TECHNICAL SERVICE BULLETIN

TSB# **17-005** **Date of Publication** February 2017

Inspect Omega Control Board to confirm if a D series
Replace D series Omega Control with C2 Series

2017 North Point Fifth Wheel
387RDFS **H1LZ0153-0174**

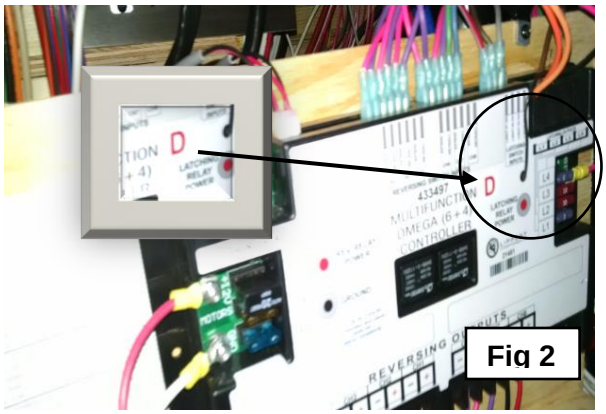
STEP 2:
Fig 2: Inspect the Omega Control panel. If the panel is labeled revision **"D"** it must be replaced with a C2 board.

YOU MUST RETURN THE D SERIES BOARD TO JAYCO FOR CLAIM TO BE PROCESSED.

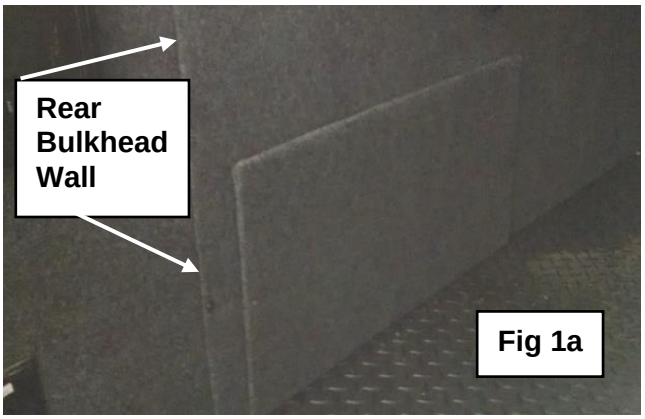
STEP 1
Fig 1a Remove 4-6 screws from the rear bulkhead wall to gain access to complete Omega control (4-6 screws).

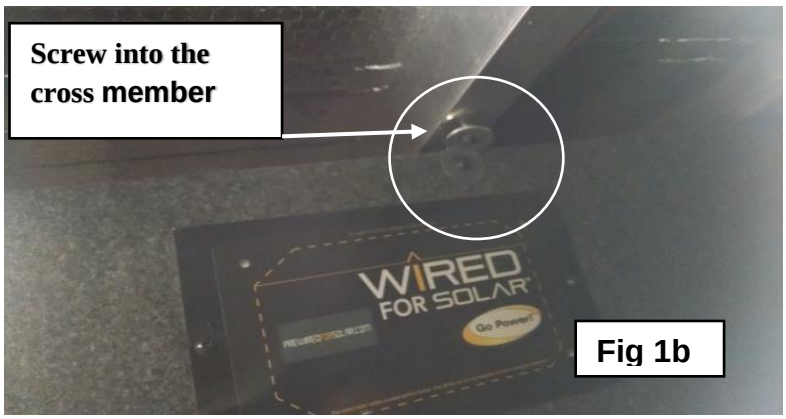
Fig 1b Note: Remove screws through the cross members at top of rear bulkhead wall to gain access to the entire control.

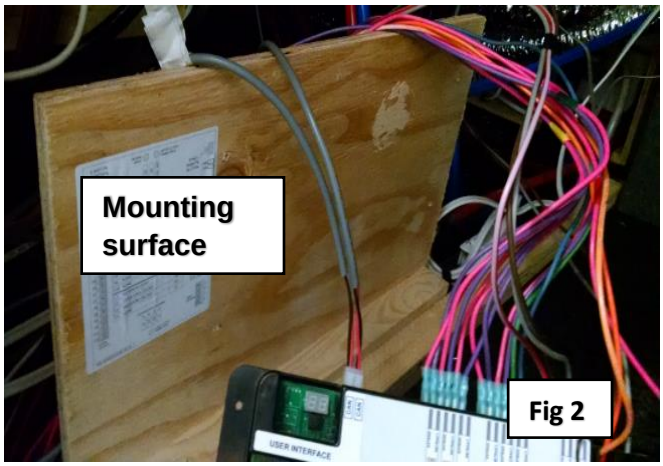
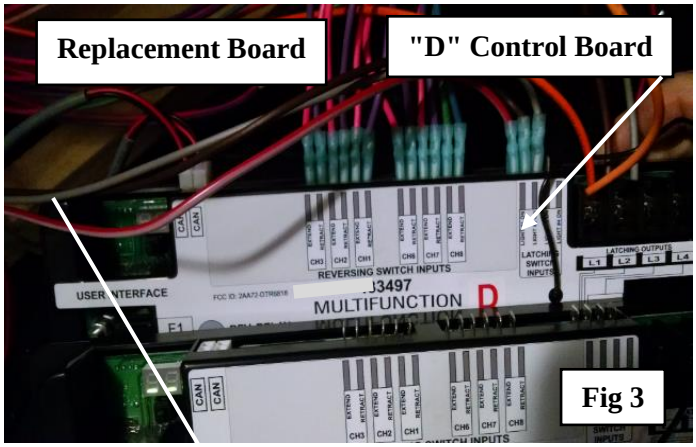
STEP *2:*
Fig 2: Remove screws used to attach Omega Board to mounting surface.

STEP 3:
Fig 3: Place replacement Omega Board on top the "D" Series Omega control.

NOTE: Move 1 connection at a time. If there are empty connection spaces on the "D" series Control Board leave the same empty connection spaces on the replacement board. Do not completely remove wire attachment screws - doing so creates unnecessary difficulty when reinstalling wires.

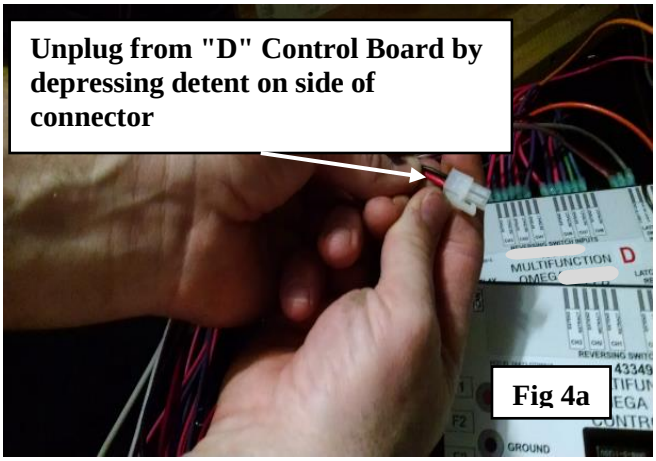
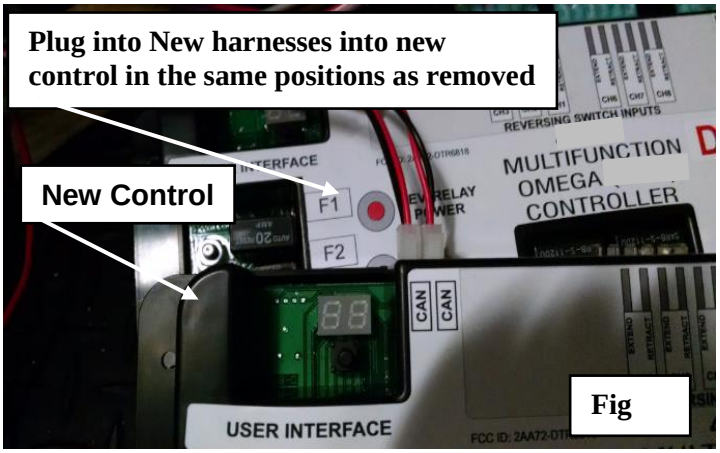
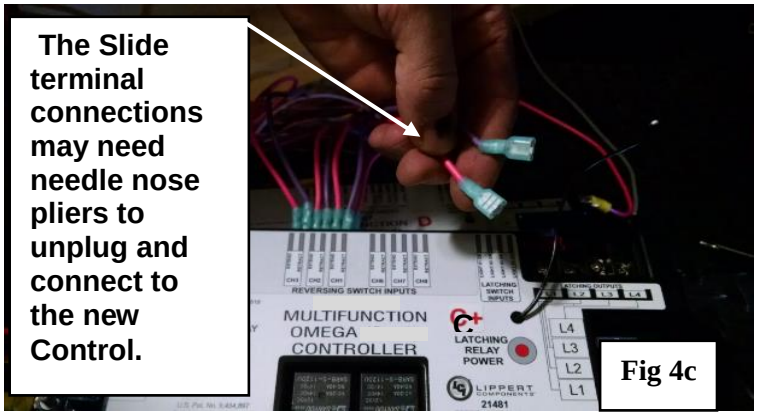
STEP 4:
FIG 4a,b,c: Transfer each wire from the “D” series Control to the replacement control. Wire Attachments points on the new control MUST match those on the original.

Fig 5a

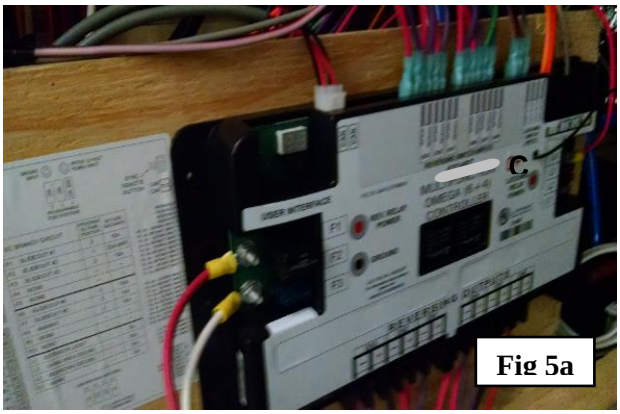
Fig 5a & 5b After all connections are transferred, attach replacement control to mounting surface in the original position.

FIG 6

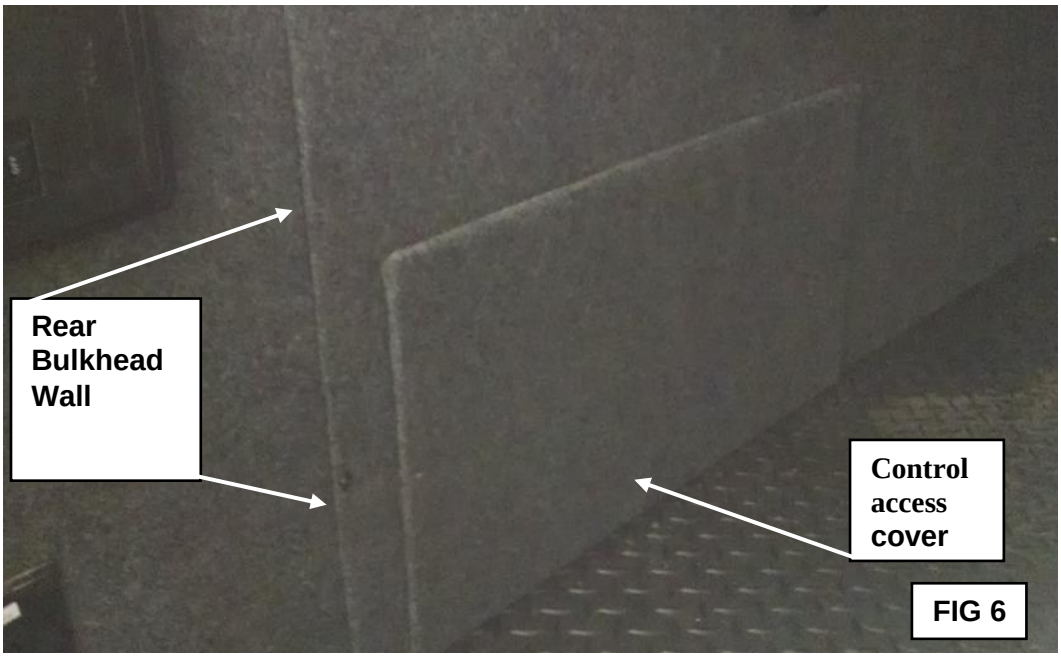
FIG 6 Reinstall rear bulkhead wall including bracket at overhead cross members.
